Project	IEEE 802.16 Broadband Wireless Access Working Group http://ieee802.org/16 >					
Title	The unified TLV encoding for DCD and UC	D in OFDMA PHY mode				
Date Submitted	2004-11-01					
Source(s)	Yeongmoon Son, Jungje Son, Changhoi Koo, Hyoungkyu Lim, Steve Lee, Hyunjung Kang Samsung Electronics Co. Ltd. Voice: +82 31 279 5845 FAX.: +82 31 279 5130 ym1004.son@samsung.com					
Re:	IEEE 802.16d D5 Draft Corrigenda	·				
Abstract	To correct error in 802.16d/D5. This contribution proposes a additional and single TLV encoding which unifies all the TLV encodings of UCD or DCD					
Purpose	Discuss and adopt proposed text and TLV encodings for corrigenda					
Notice	This document has been prepared to assist IEEE 802.16. It is offered as a basis for discussion and is not binding on the contributing individual(s) or organization(s). The material in this document is subject to change in form and content after further study. The contributor(s) reserve(s) the right to add, amend or withdraw material contained herein.

The unified TLV encoding for DCD and UCD in OFDMA PHY mode

Yeongmoon Son, Jungje Son, Changhoi Koo, Hyoungkyu Lim, Steve Lee, Hyunjung Kang

Samsung Electronics Co. Ltd

Figure 1 – The proposed operation of the unified TLV encoding

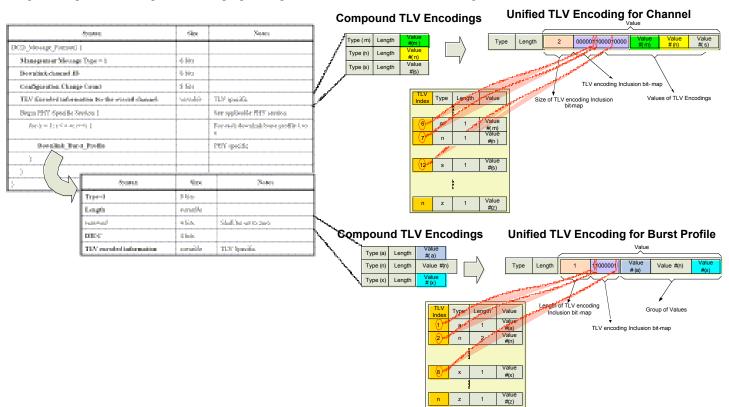
Each bit of *TLV encoding Inclusion bit-map* indicates the existence of Value assigned to the relevant TLV Index. In other words, the most significant bit (MSB) is assigned to TLV index #1, subsequent bit relates to TLV index #2. Whenever a bit of *TLV encoding Inclusion bit-map* is set to '1', Value assigned to the pertinent *TLV index* is added to the *Group of Values*.

Group of Values is composed of the values whose bit in TLV encoding Inclusion bit-map is set to '1'. In other words, whenever a bit of TLV encoding Inclusion bit-map is set to '1', Value mapped to the pertinent TLV index, is concatenated to the Group of Values.

Figure 1 depicts the example about the proposed operation of the unified TLV encoding.
